From: [David Hay](#)
To: [Mark Ross](#)
Subject: Pohuehue Rd - Response to Q17 of the S92
Date: Friday, 19 December 2025 1:51:00 pm
Attachments: [image001.png](#)
[image002.png](#)
[image003.png](#)
[image004.png](#)
[image005.png](#)
[image006.png](#)
[image007.png](#)
[image008.png](#)
[Updated Appendix Four - Stormwater and Wastewater Report.pdf](#)

Subject: RE: Pohuehue Rd - Response to Council Comments on S92 Response.

Subject: Pohuehue Rd - Response to Council Comments on S92 Response.

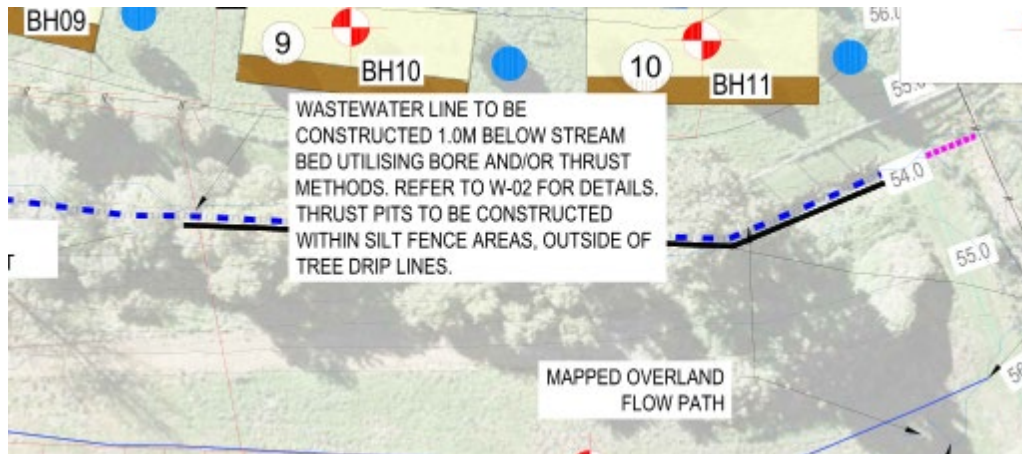
To further assist Council we have provided a further updated Sheet 10 (included in the Engineering response) which now identifies that the installation of the wastewater line underneath the watercourse will be by trenching or thrusting. A snip of this is below.

Q3 We identified that the wastewater line is going under the stream. This was clear on Sheet 10 but as noted above the note has been expanded so it is very clear.

Q4 Even though it is very obvious that drilling (or thrusting) a small diameter (63 mm) wastewater line a minimum of 1 m underneath a watercourse will have no effect on the watercourse we will now outline this even clearer for Council in the following assessment.

- (1) The activity must comply with the standards in E3.6.1.14 above. **See below**
- (2) The structure must be installed without disturbing the bed. **As the line will be drilled underneath the watercourse it will not disturb the bed.**
